RE: NR 716 Site Investigation Work Plan

Former We Energies 3rd Ward MGP Site
Milwaukee, Wisconsin 53202

RE: NR 716 Site Investigation Work Plan
Former Third Ward MGP Site
Milwaukee, Wisconsin
BRRTS #02-41-000320 (Peters=Johnson 3rd Ward Coal Gas MGP);
02-41-557054 (3rd Ward Coal Gas MGP/City of Milwaukee);
02-41-557057 (Hoffmann);
02-41-577202 (One Catalano Square)

RESPONSES TO NOVEMBER 15, 2018 LETTER

PLANT OPERATION CSM
FORMER THIRD WARD MGP
MILWAUKEE, WISCONSIN

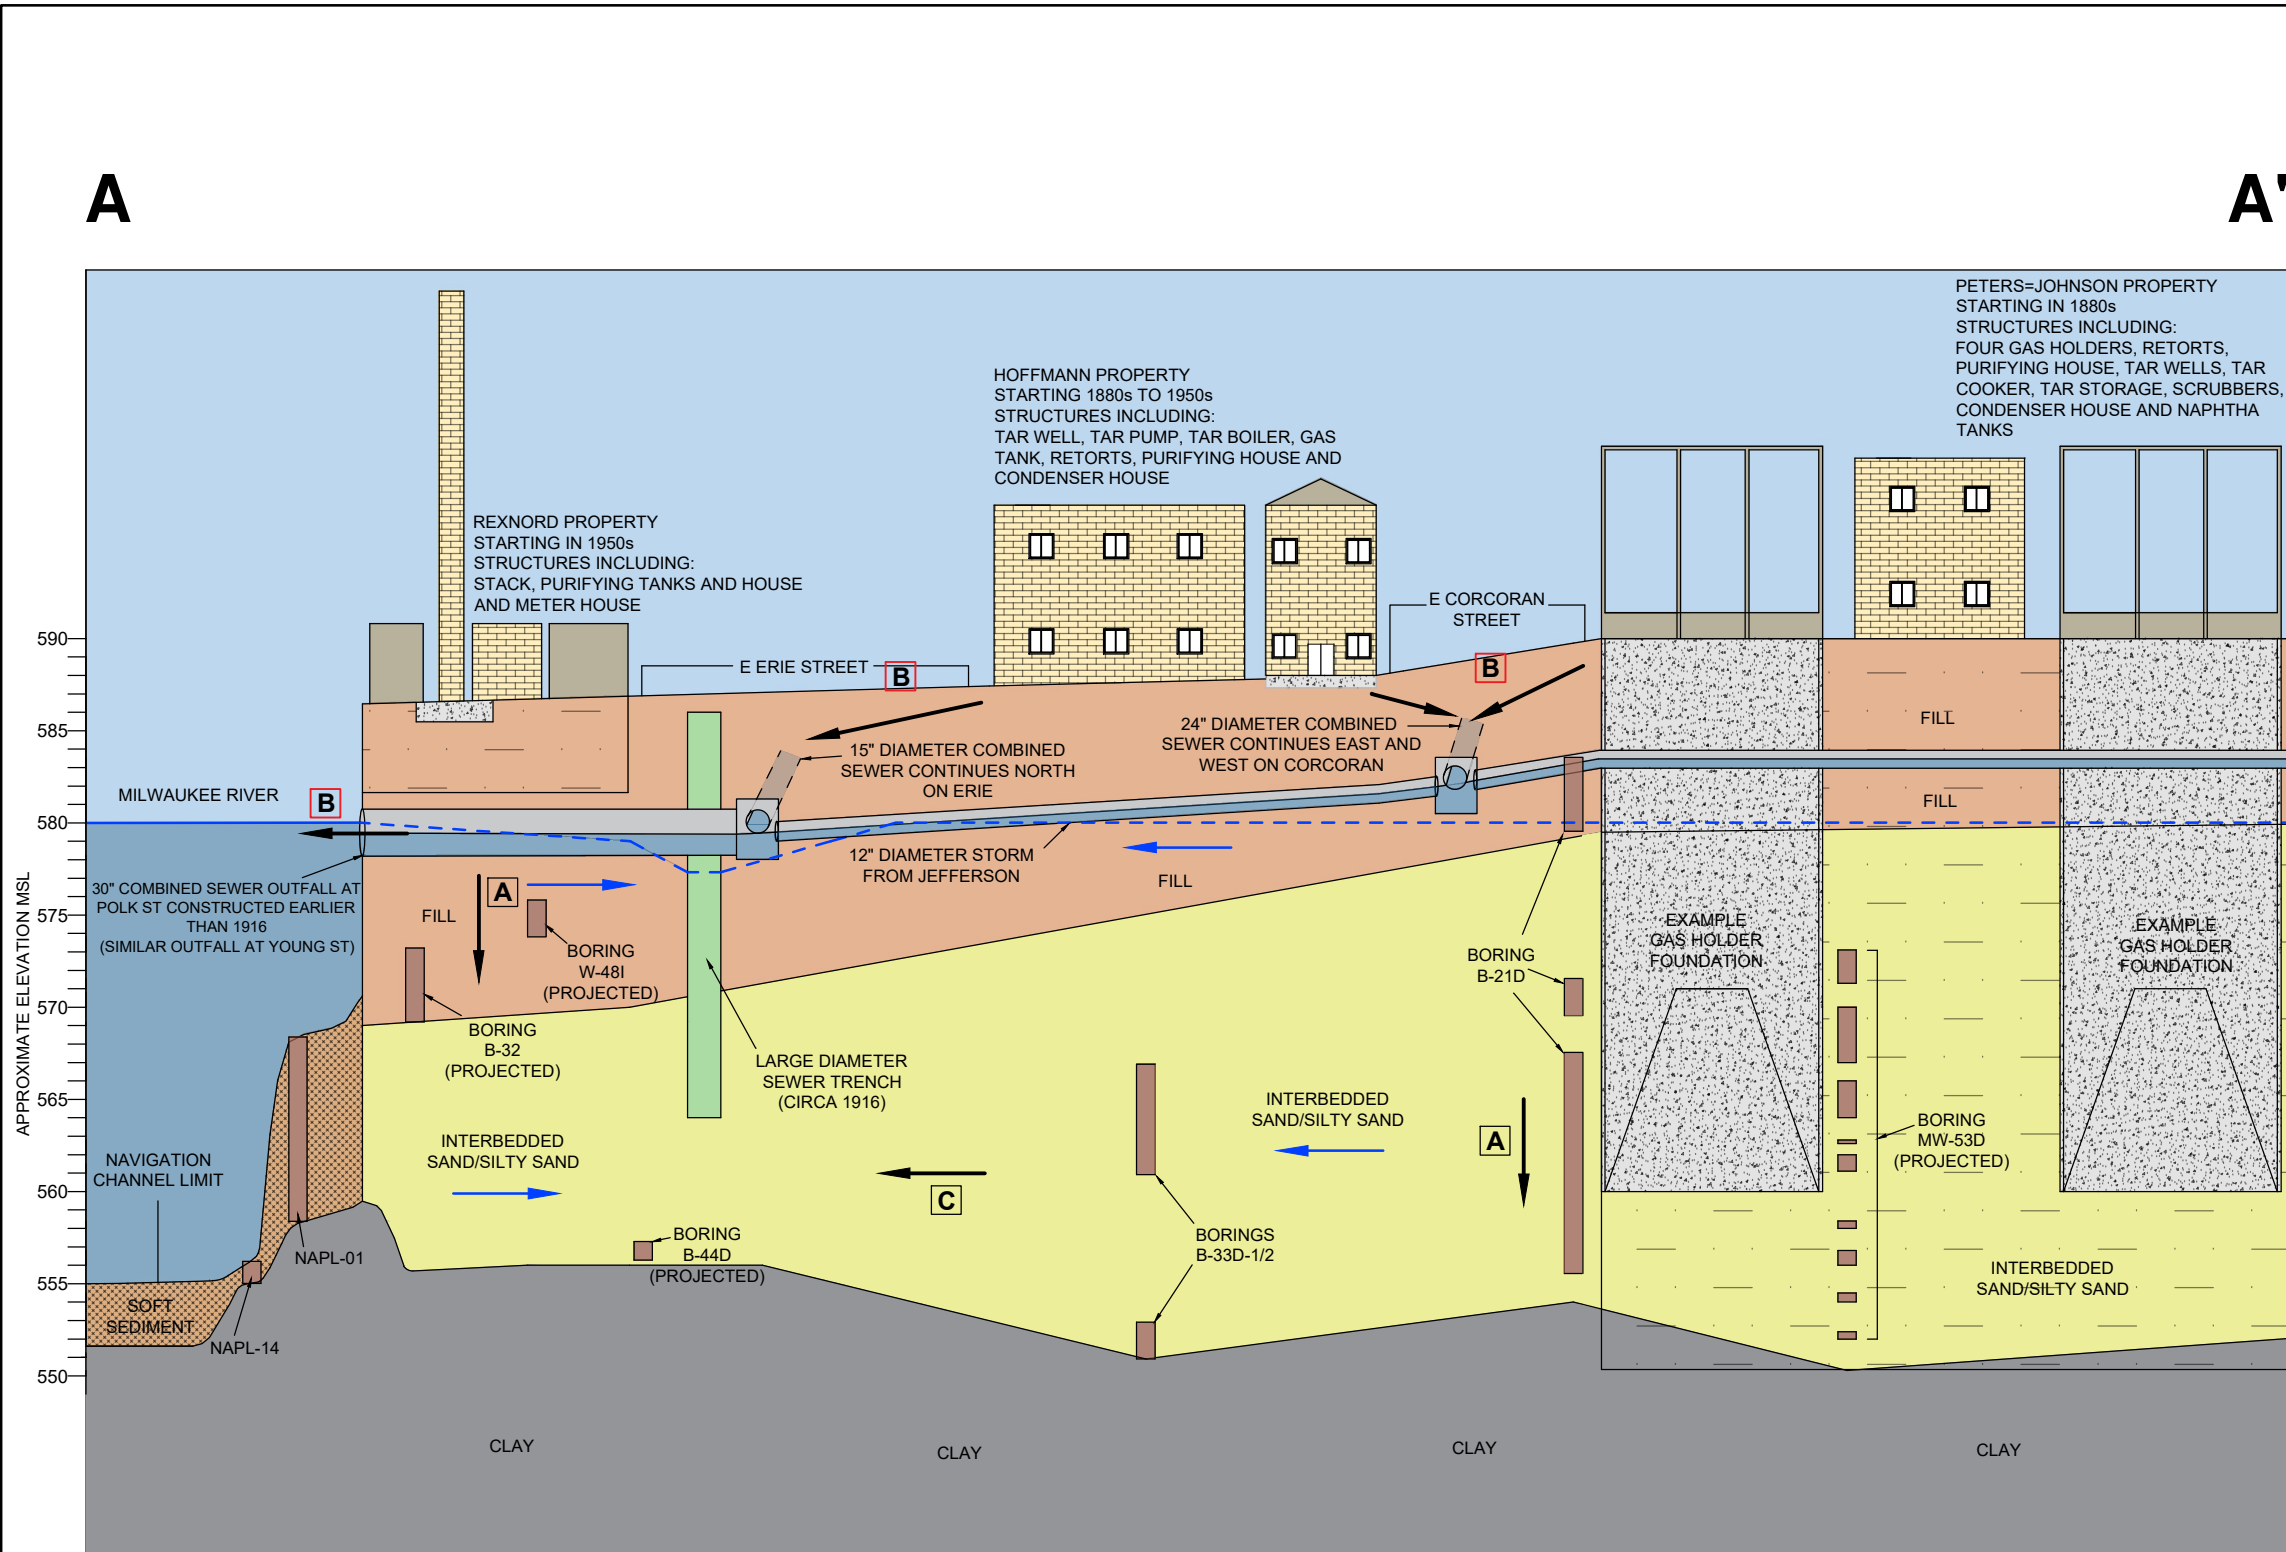
1a. Determine how the MGP residuals entered the river and evaluate if river sediments continue to be impacted by an ongoing discharge of MGP residuals from the Site

Historic/Plant Operation: Three potential migration pathways are described (A, B, and C). A vertical pathway through the soil matrix of the dense non-aqueous phase liquid (DNAPL) is shown as A. Pathway B illustrates the potential for flow of NAPL through the sewers (which were present prior to 1916 and during operation of the plant) into the river via historic 30" diameter outfalls at both Jefferson/Polk St. (near the former railroad bridge) and Young St./Broadway St. near the Young St. bridge (these outfalls are also coincident with thicker NAPL observations found in recent sediment investigation activities). This pathway likely included other smaller outfalls which existed within the property along the river. The applicable MMSD sewer maps and details for this 1916 sewer construction are provided in Attachment 2. Pathway C is a possible secondary horizontal pathway of

DNAPL through interbedded sand lenses. Review of boring logs for two geotechnical borings performed before the DoMus building construction did not indicate the presence of NAPL in sand or sand lenses above the clay layer, supporting the likely dominant Pathway B through the sewers.

Response: OBG has prepared conceptual site models (CSMs) for both the historic/plant operation timeframe (Figure 1) and the present day timeframe (Figure 2). These CSMs are attached for WDNR's review and comment. Main points from these CSMs are:

VAPOR INTRUSION SCREENING LOCATIONS

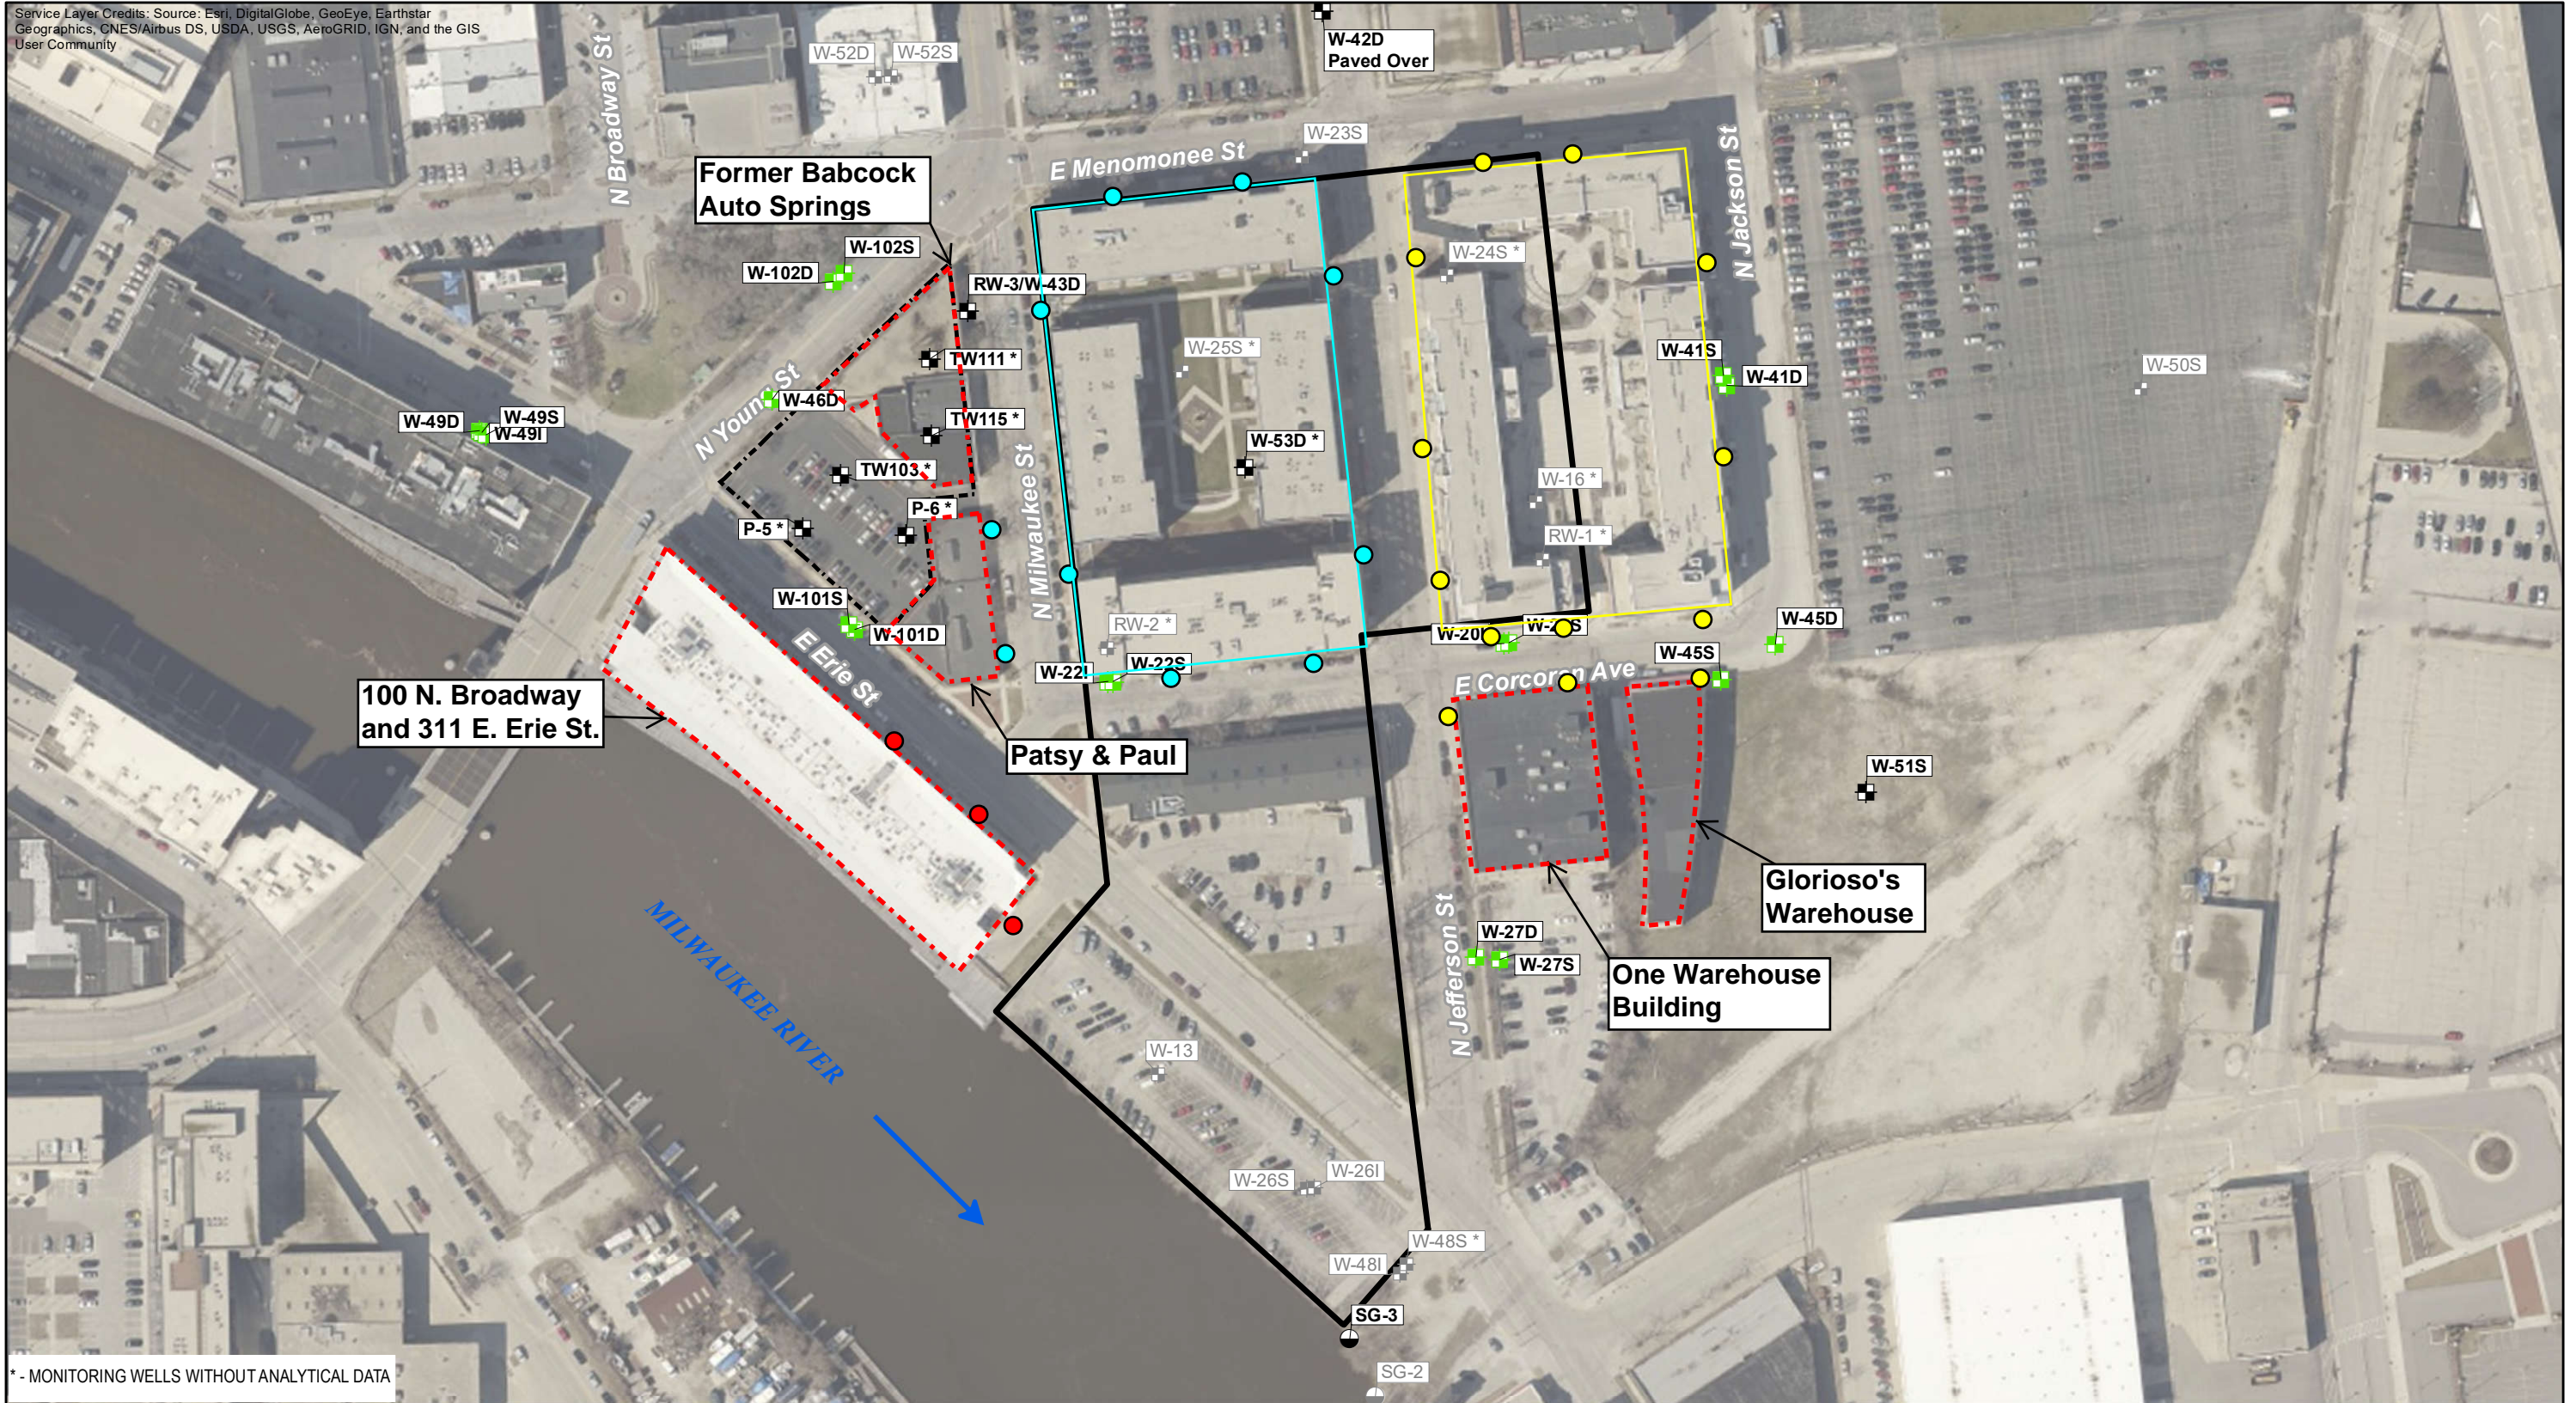
2a. Evaluate the potential for the vapor intrusion pathway to be complete at additional properties based on current groundwater sampling data. Refer to the DNR guidance document, RR-800. (A vapor sampling plan is pending review with the DNR for the Hoffmann property.) These properties include, but are not limited to:

- i. Patsy & Paul, and possibly Babcock Auto Springs depending on redevelopment plans***
- ii. One Warehouse Building***
- iii. The mixed use building southeast of MIAD (100 N. Broadway and 311 E. Erie St.)***
- iv. Glorioso's Warehouse***

Response: Vapor intrusion (VI) screening was performed for the Patsy & Paul building as part of the Peters=Johnson parcel vapor investigation (i.e., two vapor probes were performed along the east side of the building in the N. Milwaukee St. right-of-way) and VI screening was performed for the One Warehouse and Glorioso's Warehouse as part of the City of Milwaukee parcel vapor investigation (i.e., three vapor probes were performed along the north sides of those buildings in the E. Corcoran Ave. right-of-way). These prior VI screening locations are shown on Figure 3. The results of these assessments indicated that VI was not a complete secondary exposure pathway at these properties. WDNR approved the VI pathway assessment for these investigations on June 27, 2017 and April 4, 2017, respectively. As such, no additional vapor screening is planned for these buildings. The potential for VI impacts at the Babcock building will be addressed in conjunction with the planned redevelopment of this property as noted in the WDNR-approved Remedial Action Options Report (RAOR) for this parcel (letter dated September 5, 2017).

For the Marine Terminal building (100 N. Broadway and 311 E. Erie St.), a Geoprobe™ boring (advanced prior to the well installations) labeled SB-W-103 is planned in the location adjacent to the building in the Erie Street right-of-way (as shown on Figure 3). This boring will be used to not only assess shallow soil quality for vapor intrusion concerns, but also to assess if deeper NAPL impacted zones exist that need casing-off during the deeper well installation. Shallow soil assessment will be through PID reading and visual/olfactory observations. Additionally, a water table well screened in the Upper Shallow unit will be installed and sampled for VOCs in this location. This location, in addition to existing well W-101S and boring B-44D along and within Erie Street will be used to determine if vapor screening is necessary. WDNR agreed that if shallow conditions do not indicate a vapor concern, OBG should include this reasoning for the pathway not being complete per WDNR guidance (in accordance with RR-800 *Addressing Vapor Intrusion at Remediation and Redevelopment Sites in Wisconsin*). If vapor screening is determined to be necessary based on shallow soil and/or groundwater impacts, up to 3 vapor probes may be installed in the approximate locations adjacent to the Marine Terminal building shown on Figure 3. The assessment will be performed consistent with previous WDNR-approved VI screening efforts at the Third Ward Site.
